TRANS/WP.29/692

Working Party on the Construction of Vehicles

DRAFT SUPPLEMENT 8 TO THE 01 SERIES OF AMENDMENTS
TO REGULATION No. 6

(Direction indicators)

Annex 3, figure 1, amend to read:

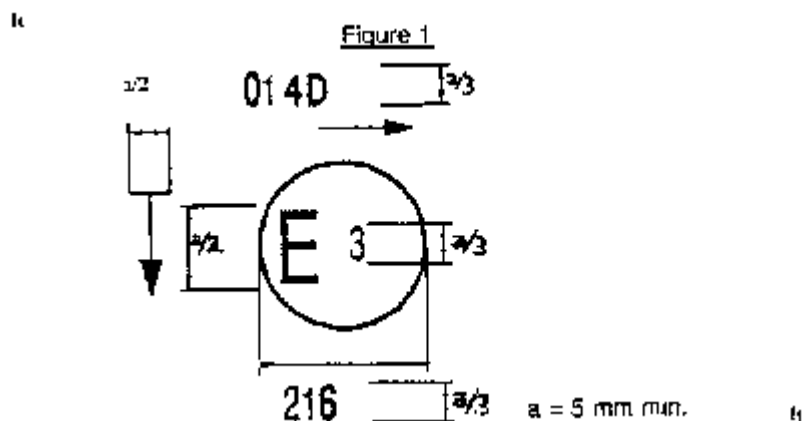
Annex 3, caption below Figure 1, first subparagraph, amend to read:

"The device two lamps. The horizontal arrow shows front of the vehicle. The vertical arrow starting from a horizontal segment and directed downwards indicates a permissible mounting height of equal to or less than 750 mm from the ground for this device."
